Recall Campaign Bulletin

Mercedes-Benz

| SUBJECT | Check Steering Coupling Bolting |
| MODEL(S) | GLC and EQE (254 and 295 platform) |

Figure 1 – looking towards front of vehicle

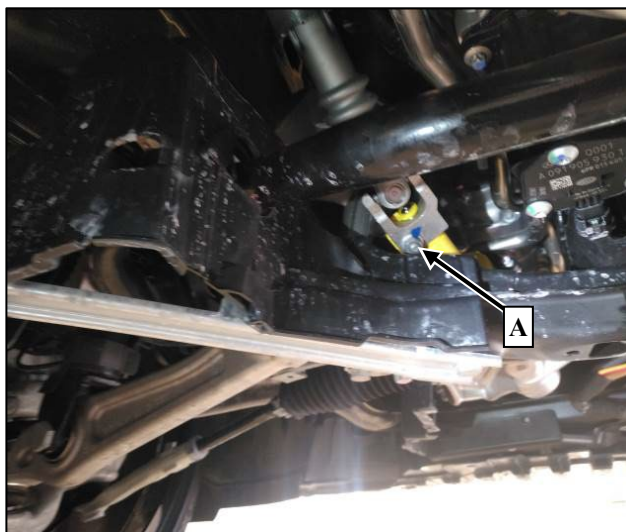
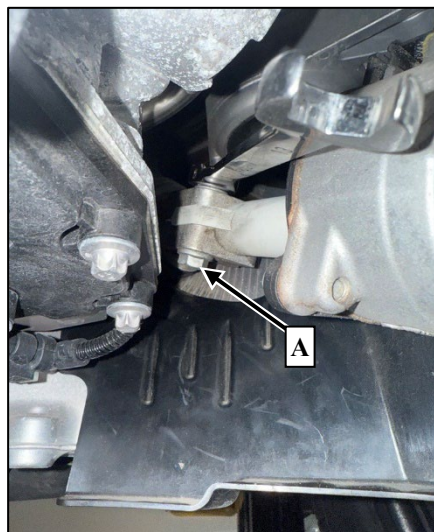
- Remove rear and center lower engine compartment lining.
 - i** For basic data on model 254, see AR61.20-P-1105WT.
 - i** For basic data on model 295, see AR61.20-P-1105EQS.
- Check torque of screw connection (**Figure 1, A**) from steering coupling to steering gear and retighten if necessary.
 - i** If damage is visible on the screw or nut, replace screw and nut.
 - Nm** Torque specification: **24Nm**
